Correction: Impact of perovskite solar cell degradation on the lifetime energy yield and economic viability of perovskite/silicon tandem modules

DOI: 10.1039/c9se90063b

Correction for 'Impact of perovskite solar cell degradation on the lifetime energy yield and economic viability of perovskite/silicon tandem modules' by Jiadong Qian *et al.*, *Sustainable Energy Fuels*, 2019, 3, 1439–1447.

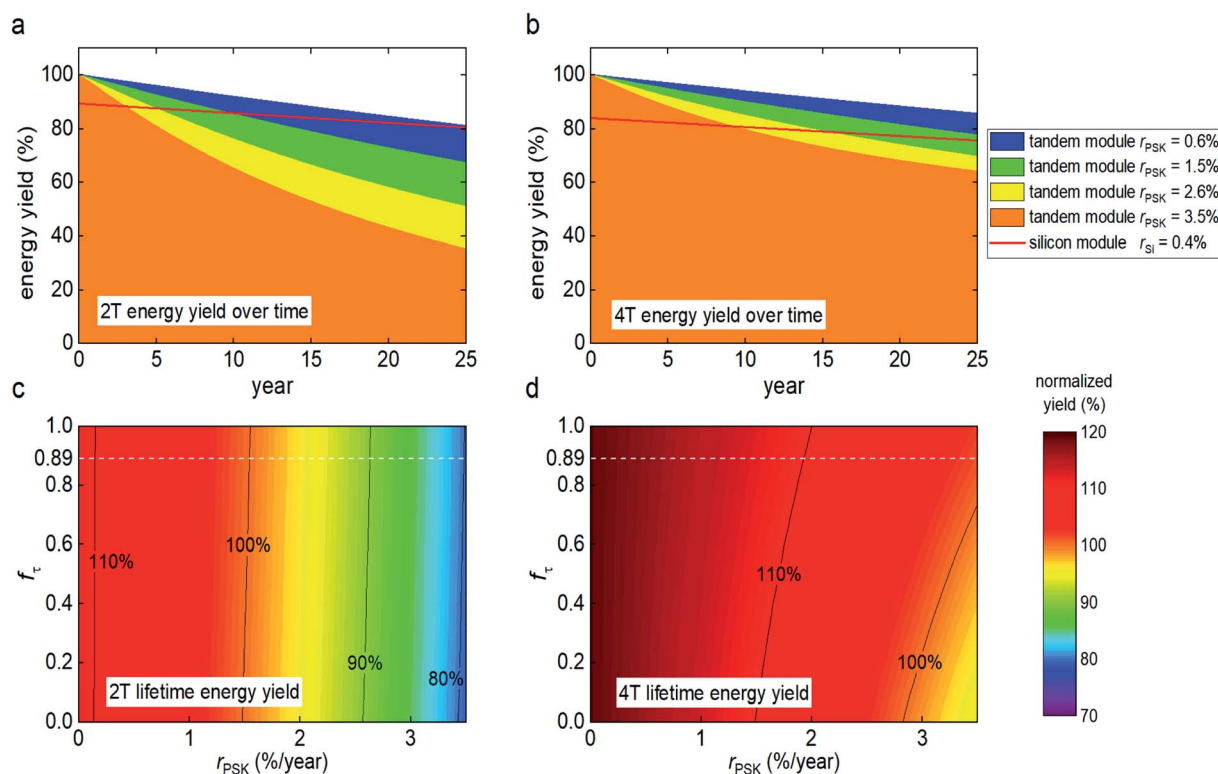
The authors regret that in the originally published version of this article incorrect results were simulated and presented in Fig. 6 and related texts. This was due to an error in the reference silicon module efficiencies.

According to the cited ref. 3 by Quiroz *et al.* and ref. 25 by Sahli *et al.* in the main manuscript, the reported silicon solar cell efficiencies without perovskite filter are 22.6% for the two-terminal and 22.4% for the four-terminal configuration, respectively.

The initially published results were mistakenly referenced as 22.5% for the two-terminal and 21% for the four-terminal module. The incorrect cell efficiencies also impacted the energy yield simulations of the two reference Si modules, and lead to an over-estimation of the energy gain from the perovskite top cells.

The authors would also like to note that a typographical error in the legend of Fig. 6 showing ' $r_{\text{Si}} = 0.5\%$ ' instead of the value of ' $r_{\text{Si}} = 0.4\%$ ' that has been used throughout the work must also be corrected. The correct value of $r_{\text{Si}} = 0.4\%$ is used in the new Fig. 6.

On page 1444, Fig. 6 and the associated caption should be as follows.
